CITY OF ALBUQUERQUE

December 27, 2021

**RE: The Wymont
4315 Wyoming Blvd NE
Grading and Drainage Plans
Engineer's Stamp Date: 11/02/21
Hydrology File: G19D004**

Based upon the information provided in your submittal received 11/01/2021, the Grading & Drainage Plan **is not** approved for Work Order and Grading Permit. The following comments need to be addressed for approval of the above referenced project:

GR-3

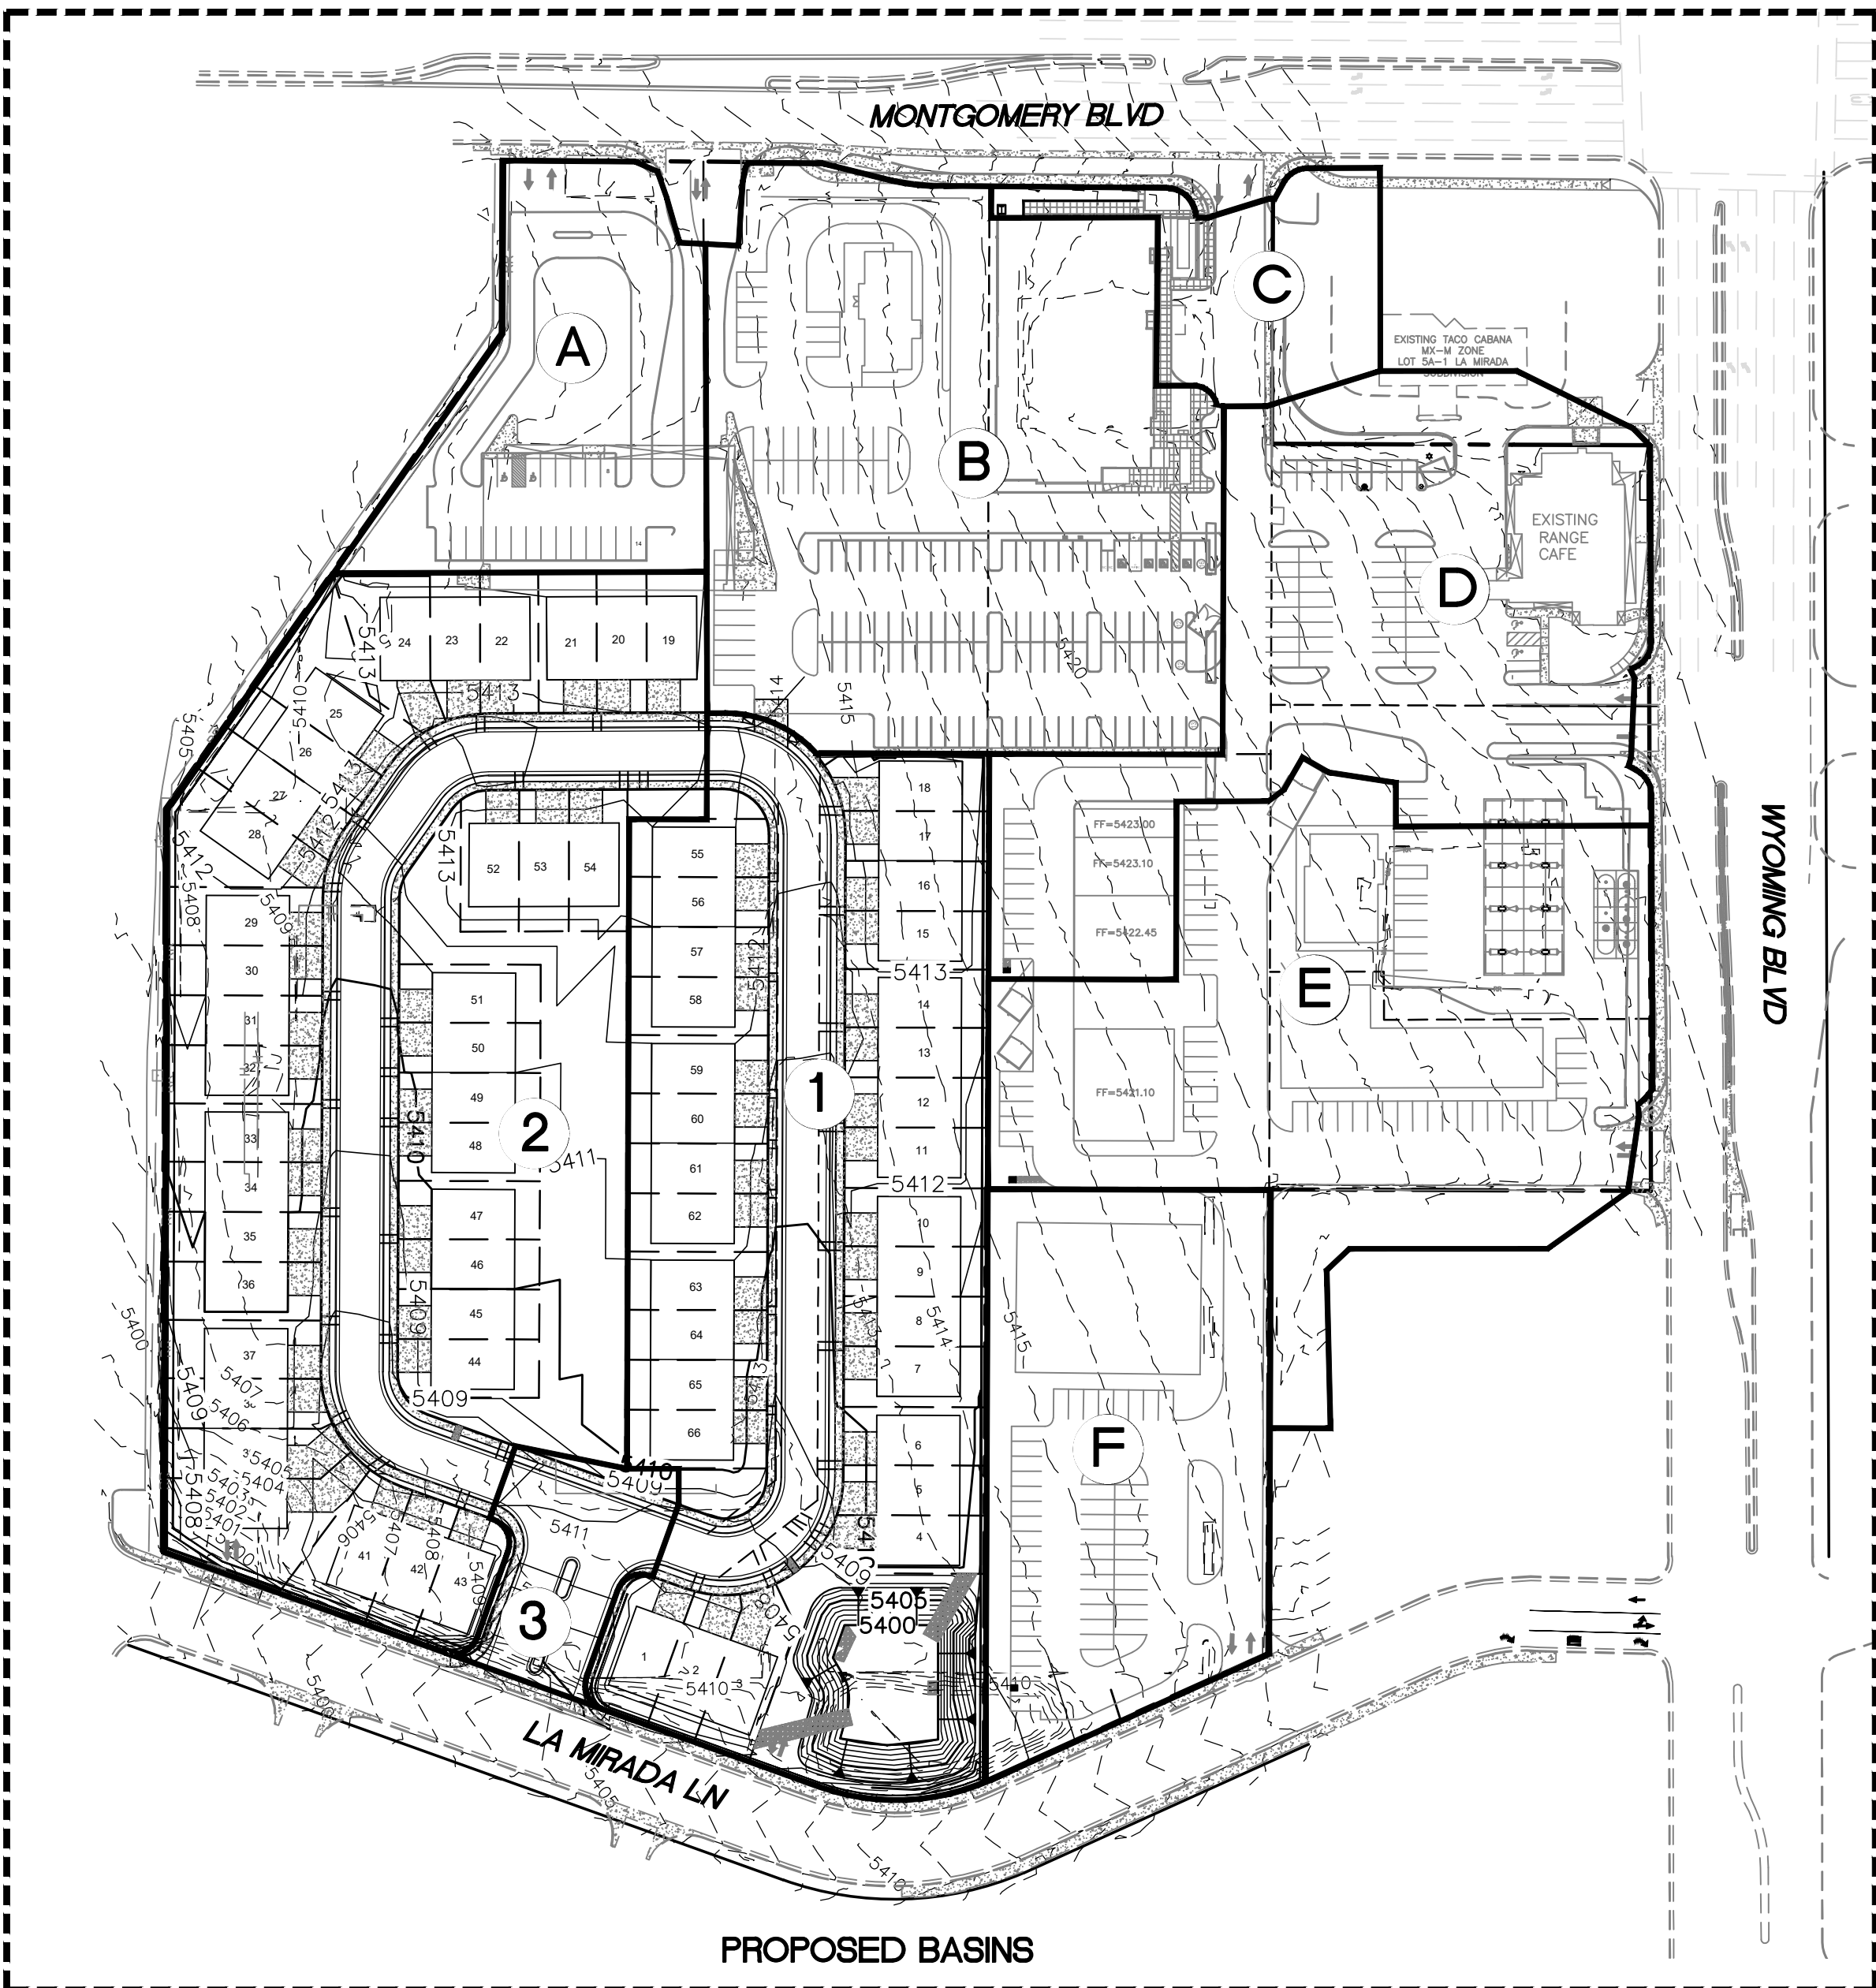
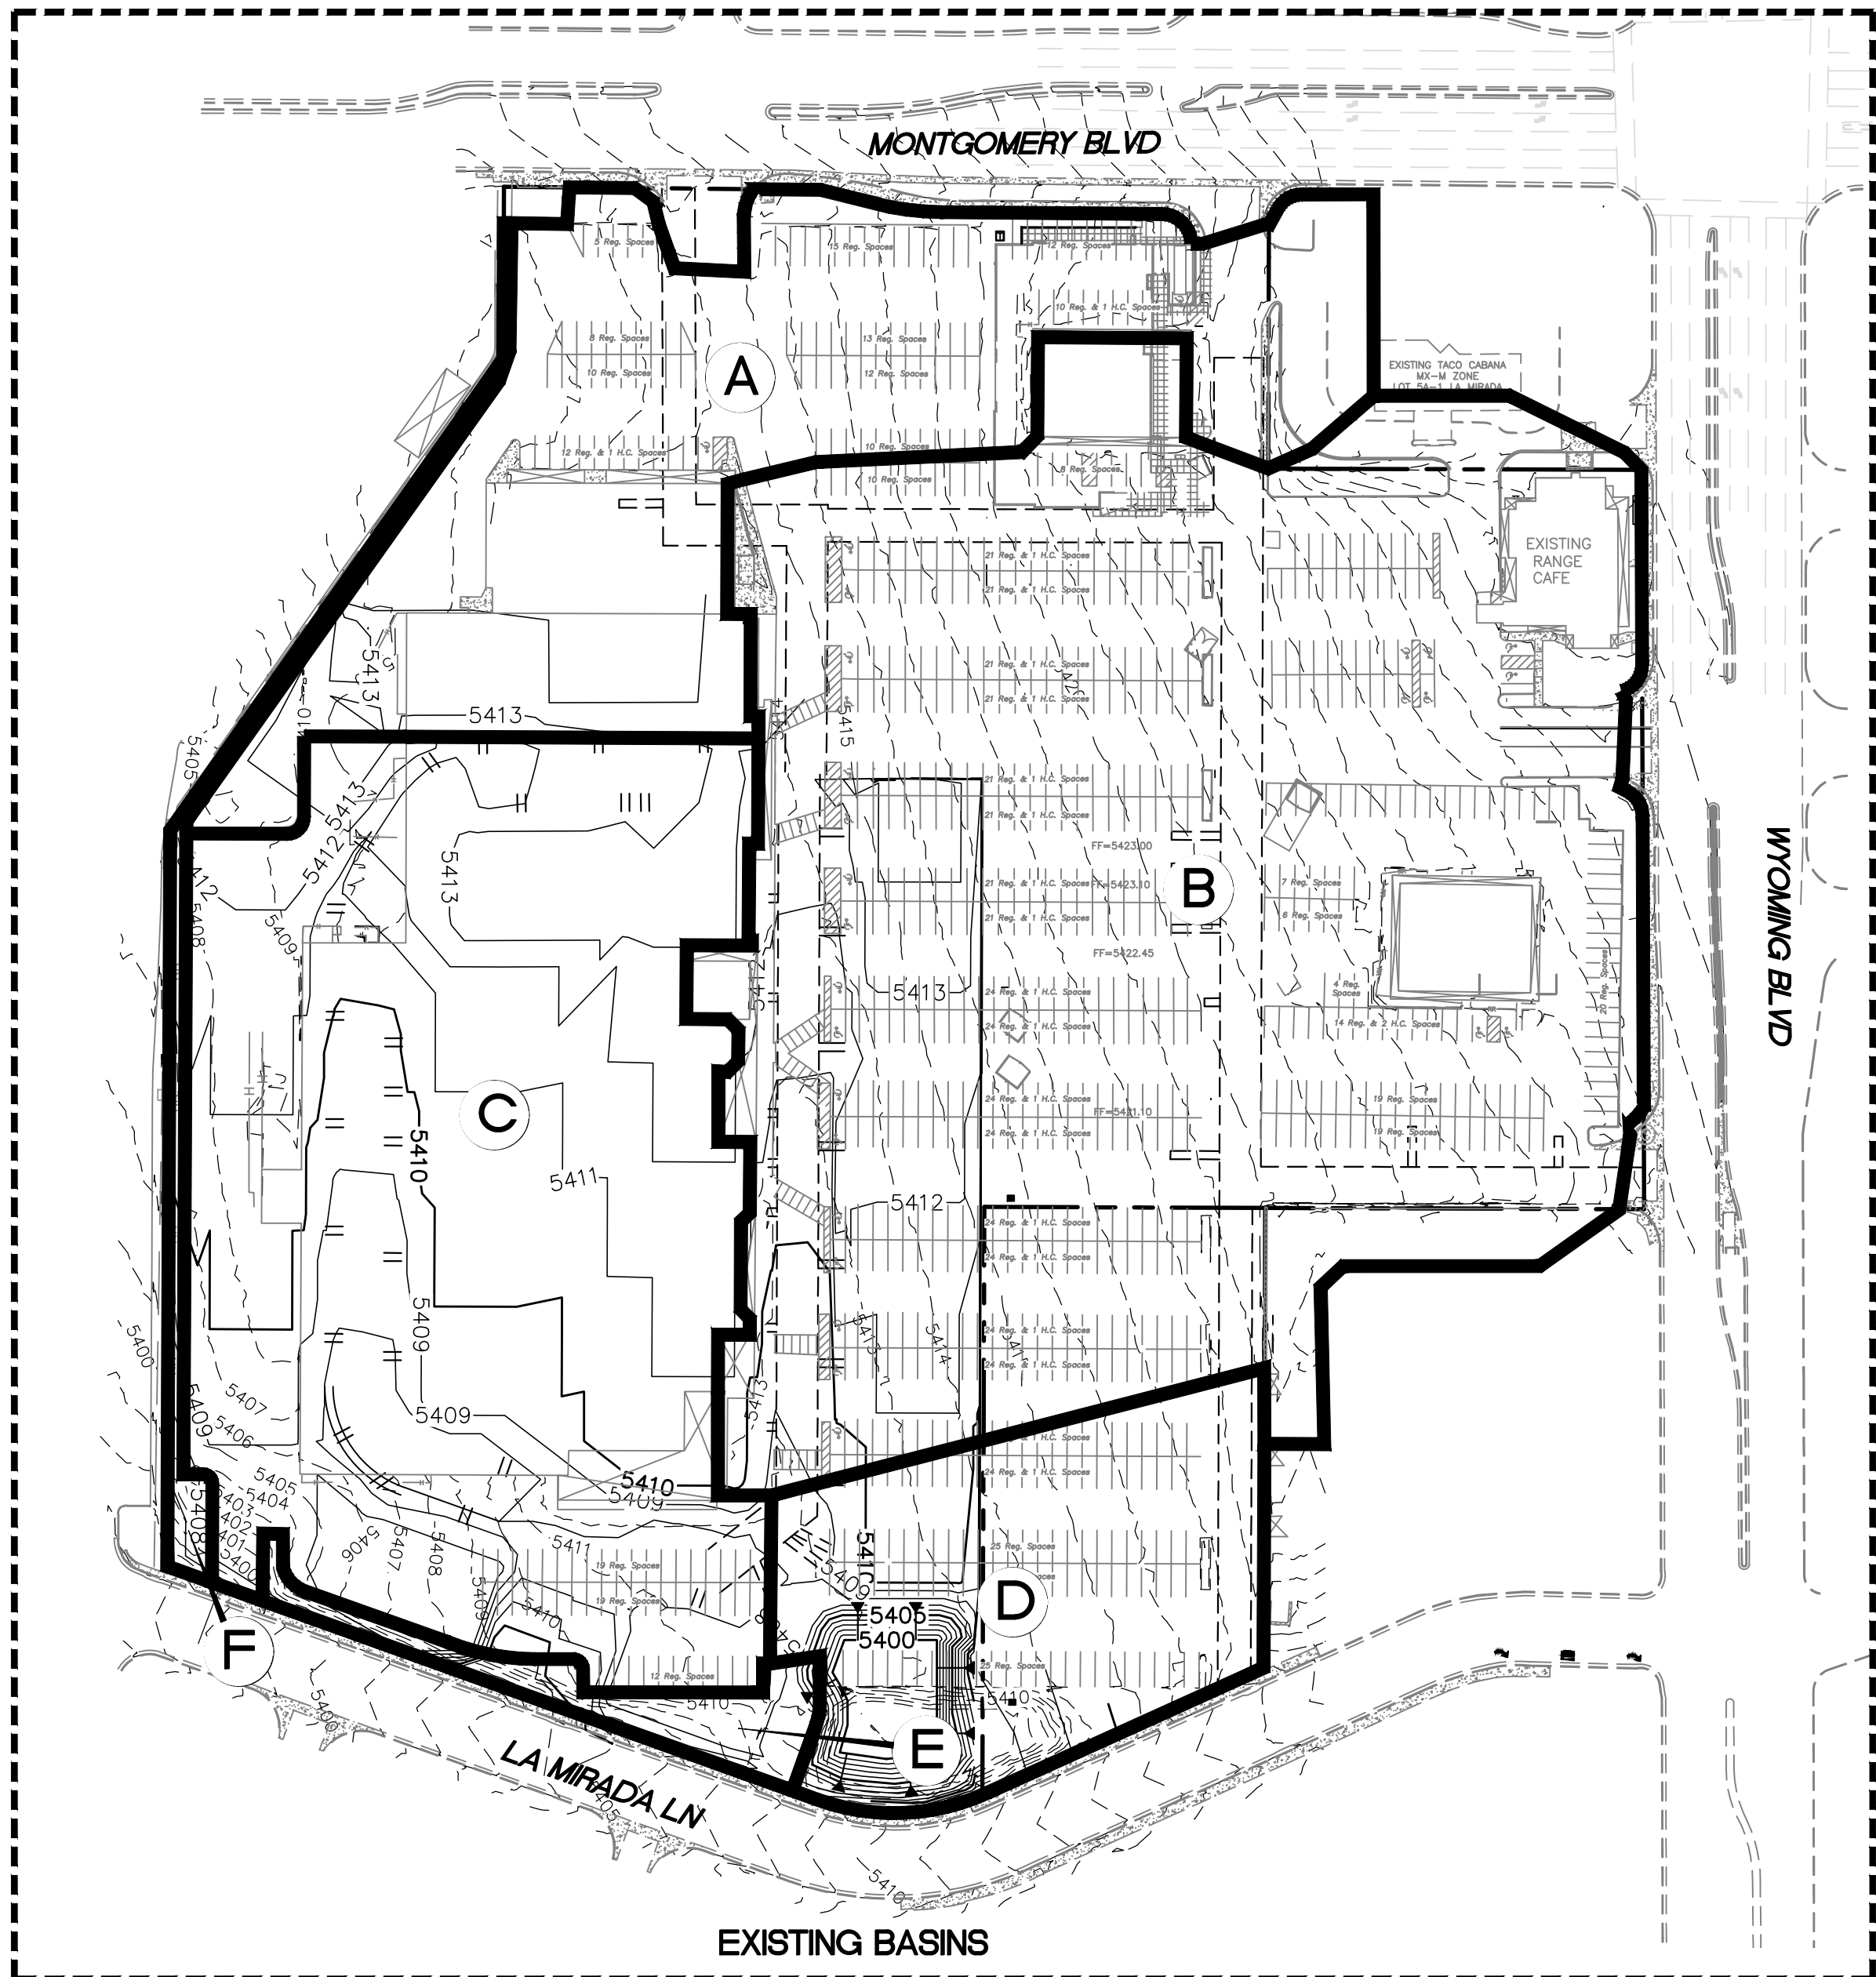
4. GR-1. Please add a note, "Side slopes need to be stabilized with Native Grass Seed (per City Spec 1012) with Aggregate Mulch or equal (Must satisfy the "Final Stabilization criteria" CGP 2.2.14.b.)". This is for the water quality pond.
5. Please make two Grading Plans at 1" = 20'. This will make the grading more readable and less congested.
6. GR-2. As with comment #4, this should be two storm pipe plans at 1" = 20'. Please add the word "Privately maintained" to all on-site storm pipes. This will also include the 24" RCP from the pond outfall structure to the new manhole in La Mirada Lane.
7. GR-3. Please relabel this as Master Drainage Plan.
8. GR-3. The Existing Drainage Area "A" drains to the west and then to the southwest as shown.

The Proposed Drainage Area "B" goes to the southwest to a proposed inlet structure (to be built in the commercial work order) and the Proposed Drainage Area "C" does not drain to Montgomery as you tried to indicate but the area currently goes to the west as outlined in the Existing Drainage Area "A". So how does this drainage area get to the proposed detention pond to the south?

9. GR-3. There is a statement about providing for a volume of 0.225 AC-FT. Please provide the hydrology routing for the detention pond as outlined in the DPM Article 6-2 Hydrology.

OUTFALL DETAIL
NTS

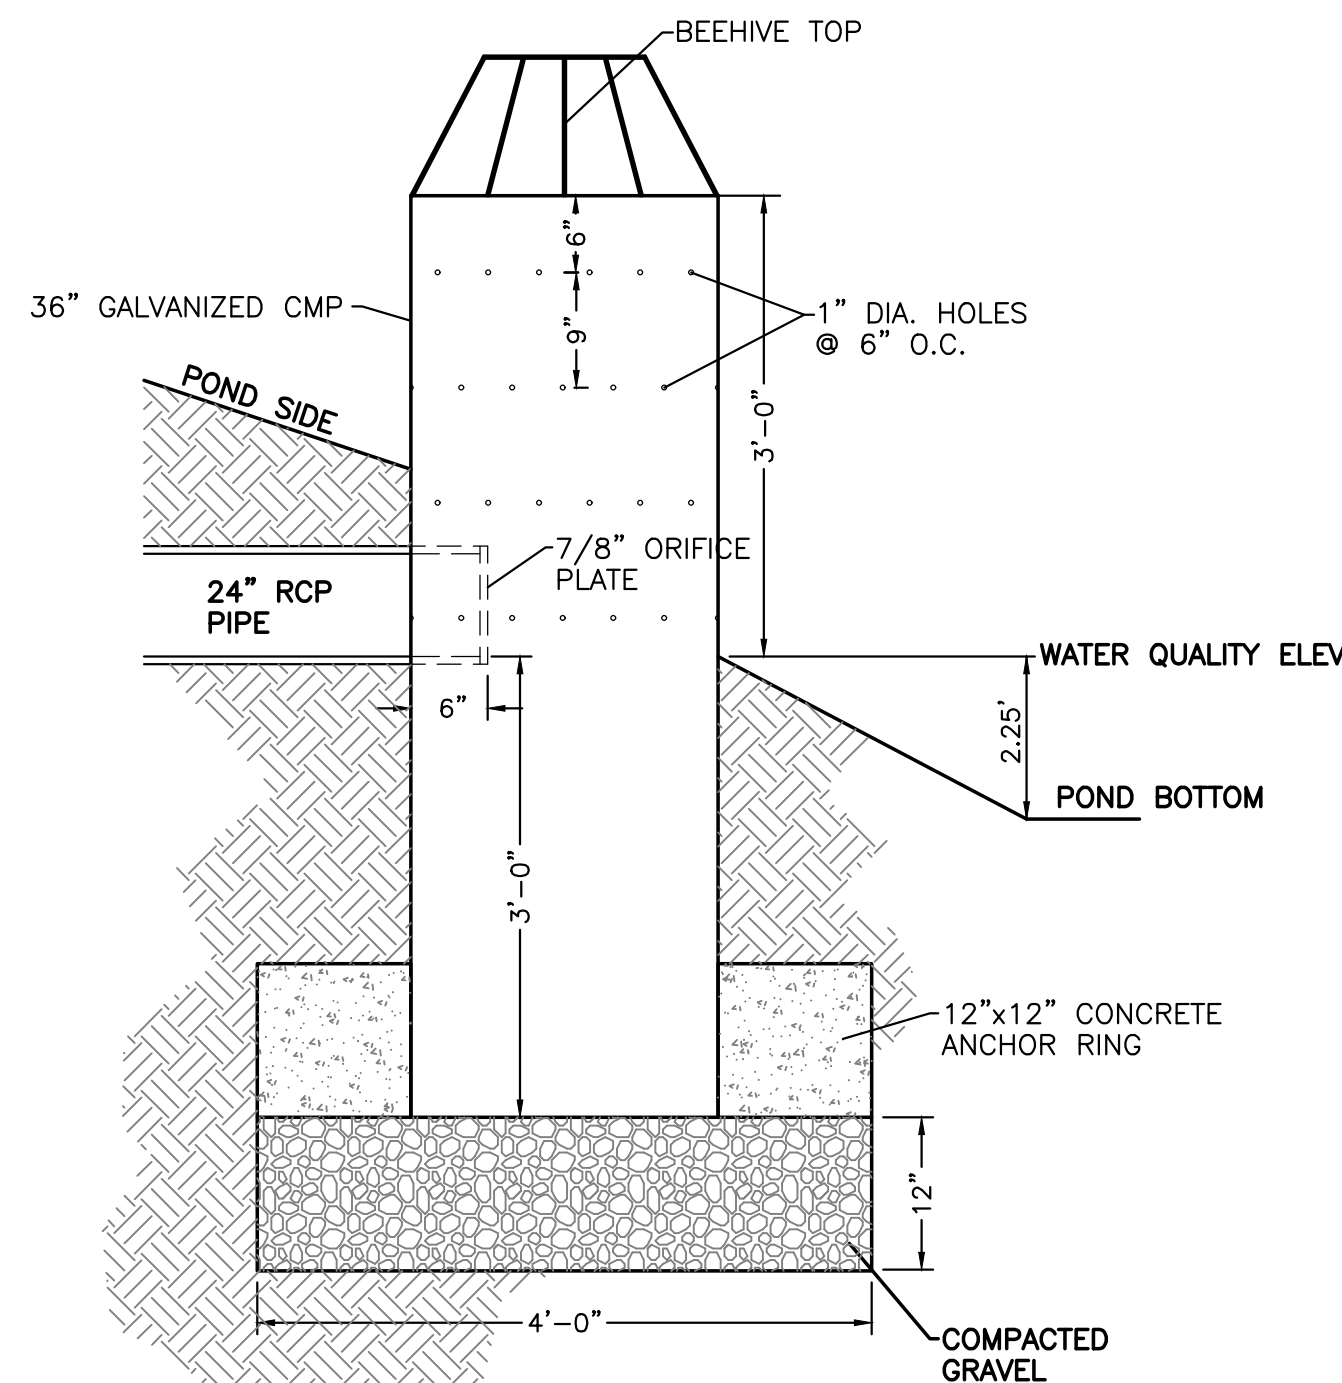
10. GR-4. Please provide the weir calculations, per DPM Article 6-16(A), for the concrete channel(s). A coefficient of 2.7 is typically used for the weir equation $Q = CLH^{2/3}$.
11. GR-4. Outfall Detail. Please provide the bottom of pond elevation, water quality elevation, top of pond elevation, and the elevation of the beehive top.

12. GR-4. Please provide the orifice calculation for the 7/8" orifice plate.
